Although 0985 and 1112 have similar physical characteristics, these drives are different. The difference is where shift lever fork slides onto drive:

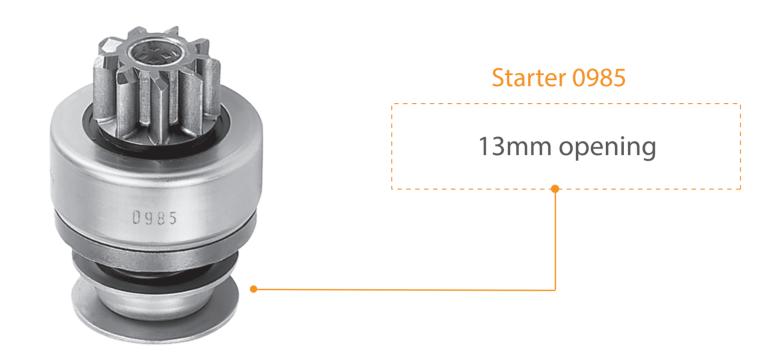
If you try to apply one for the other, the fork will not fit.
